P.O.A.D.P. PLAN  
for  
HEIGHTS @ HELOTES

Re: Heights at Helotes

POADP # 642

**P.O.A.D.P REVIEW**

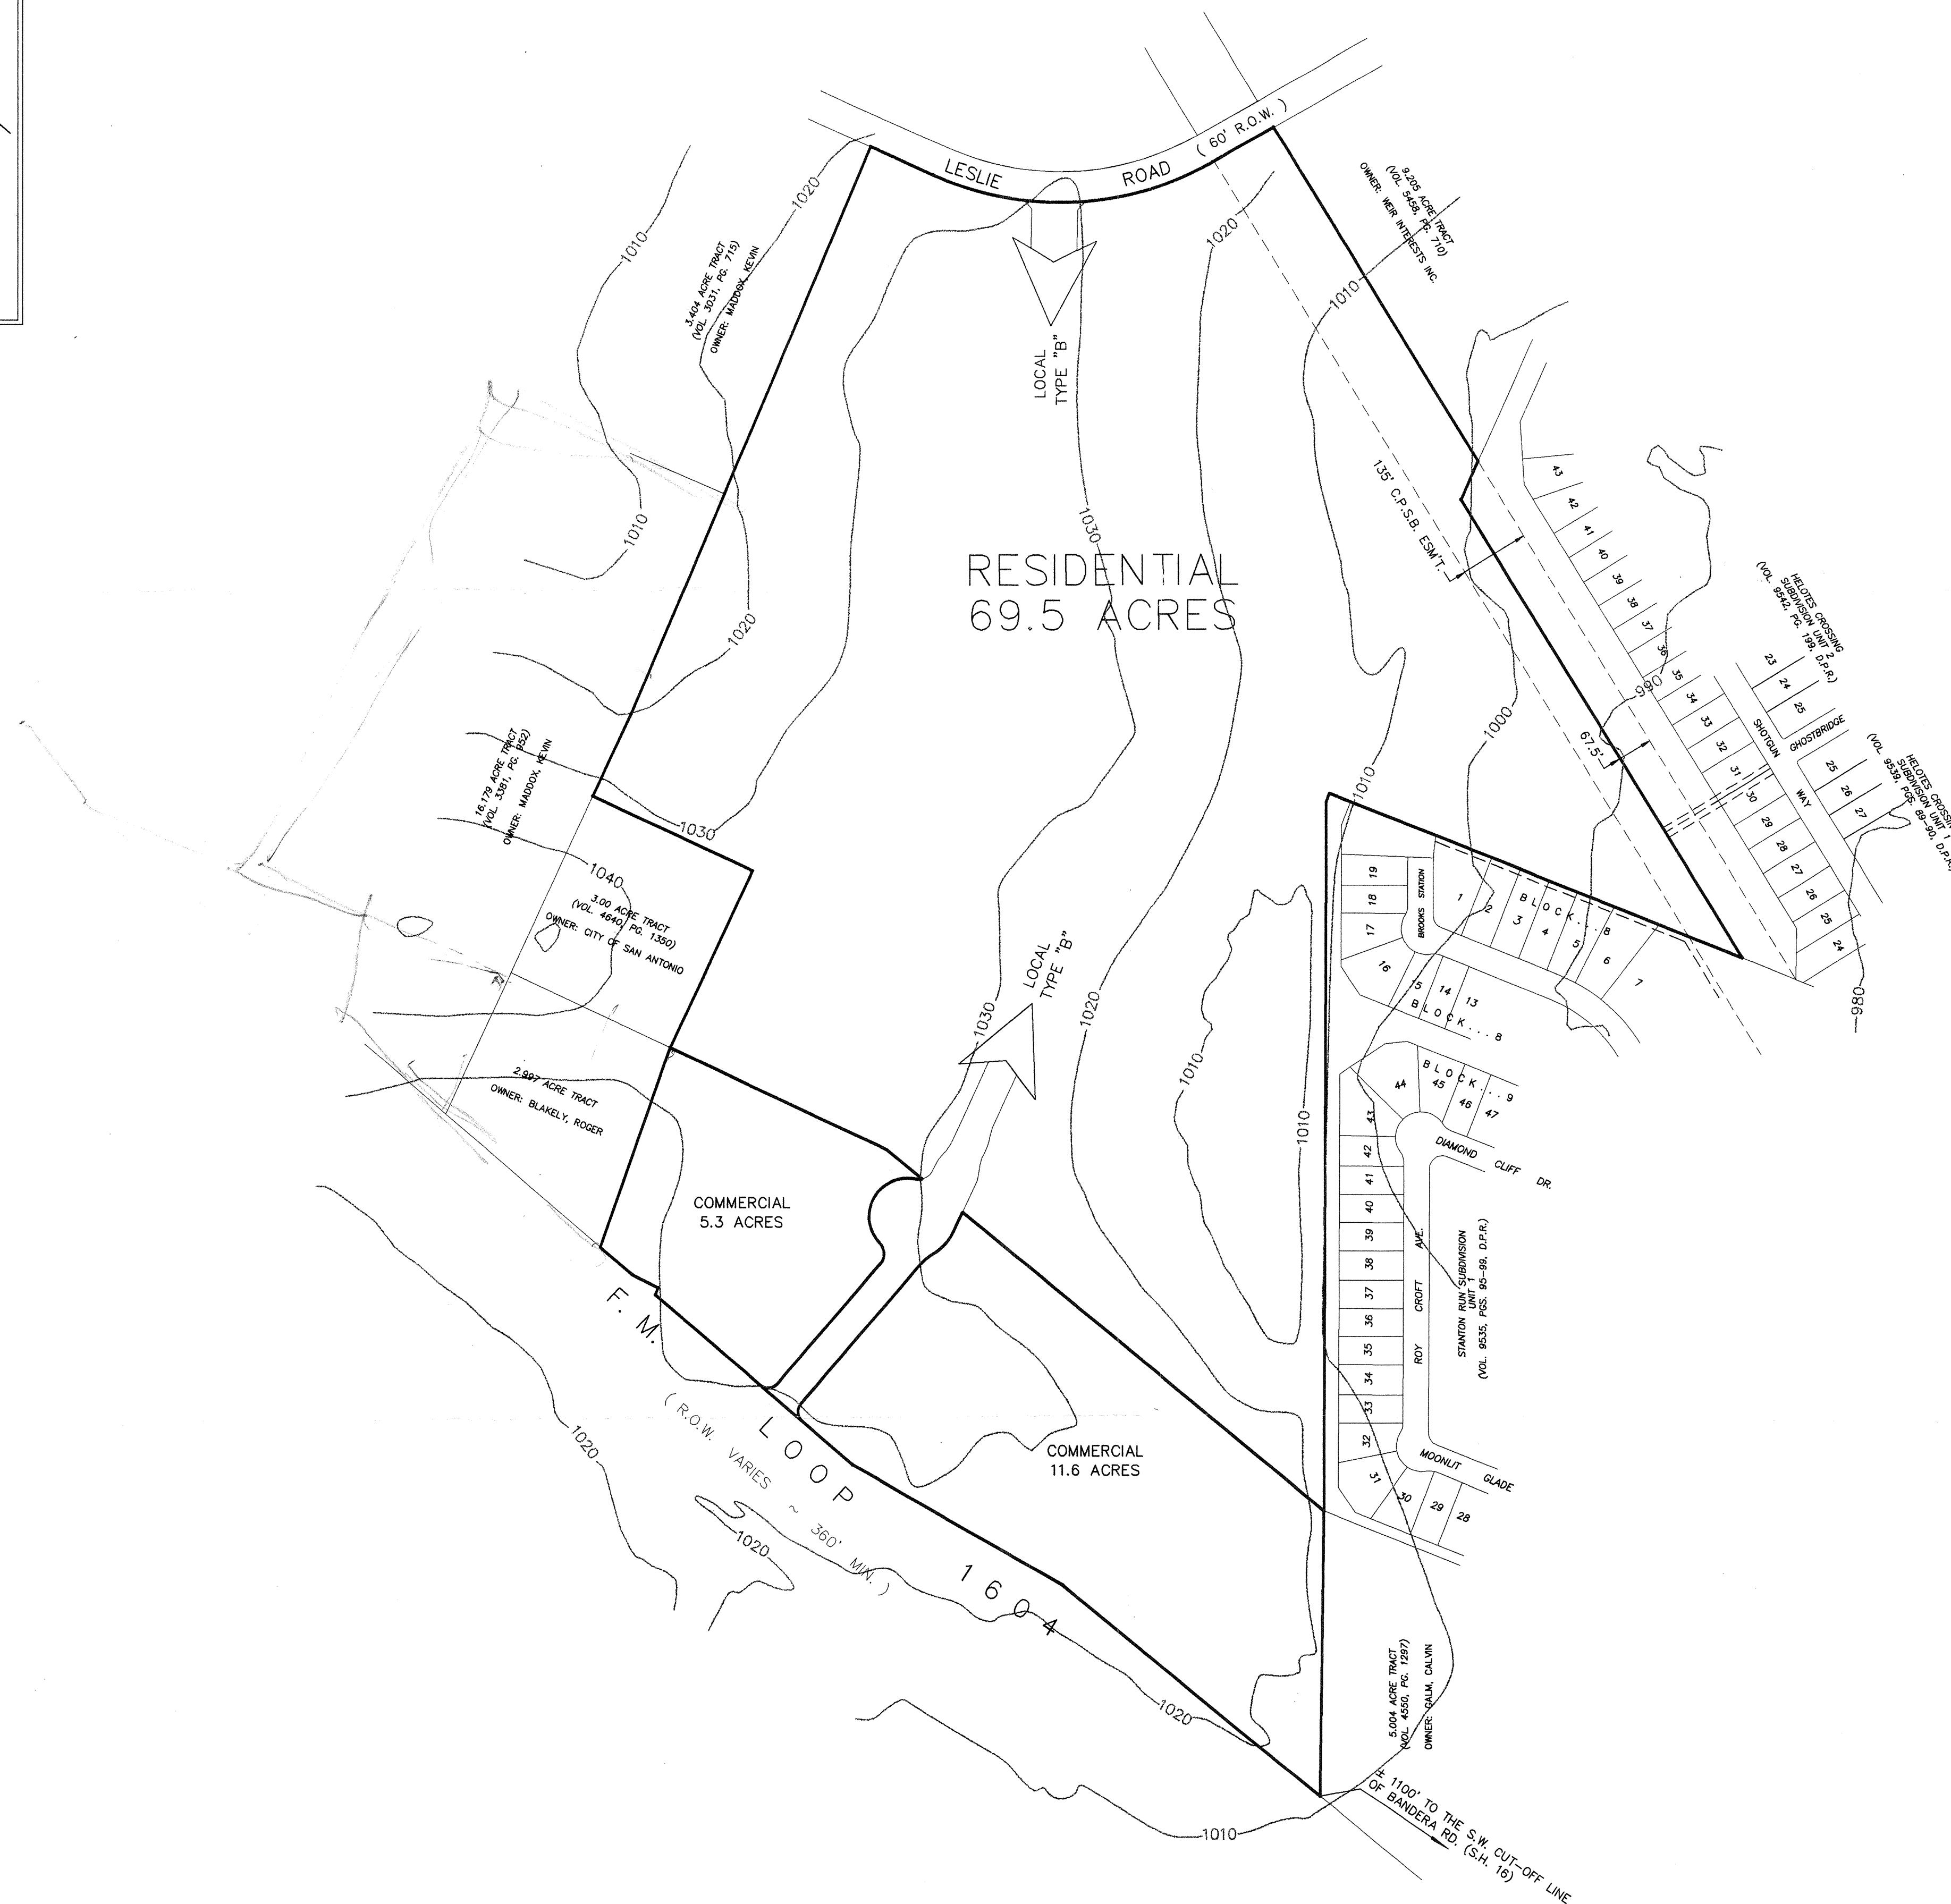
- Based on the topography, a Flood Plain Study and drainage review will probably be required during the platting process.
- In consideration of public safety and convenience, excessive grades by reason of topography should be avoided in street layouts and arrangements.

- Access and R.O.W. issues along State facilities will need to be resolved with the Texas Department of Transportation (TXDOT). For information about these requirements you can contact TXDOT at 615-5814.

- This development will need to comply with tree preservation ordinance #85262. For information about these requirements you can contact Building Inspections at 207-7102.

- It will be expected that you will plat all of the property depicted in your POADP, to include: floodpains, drainage areas and open space.
- I would encourage you to work closely with the school district, so that they can plan accordingly.

- Public Works expressed concern about having an A Local street at the entrance. This may be addressed again at the platting process.

For residential development directly adjacent to State ROW, the developer shall be responsible for adequate set-back and/or sound abatement.

50' right of way flares will be required at the intersection of the planned type "B" street and Loop 1604.

The property identified as "Commercial 5.3 acres" is eligible for a maximum combined total of two access points, which includes the type "B" street. The property identified as "Commercial 11.6 acres" is eligible for a maximum combined total of five access points, which includes the type "B" street. Locations and permitting will be as directed by "Regulations For Access Driveways to State Highways".

**ADDITIONAL COMMENTS:** An existing entrance ramp lies within the frontage of the property identified as "Commercial 11.6 acres". No access will be permitted within the gore area of this entrance ramp, and no modifications or relocation of this ramp will be permitted.
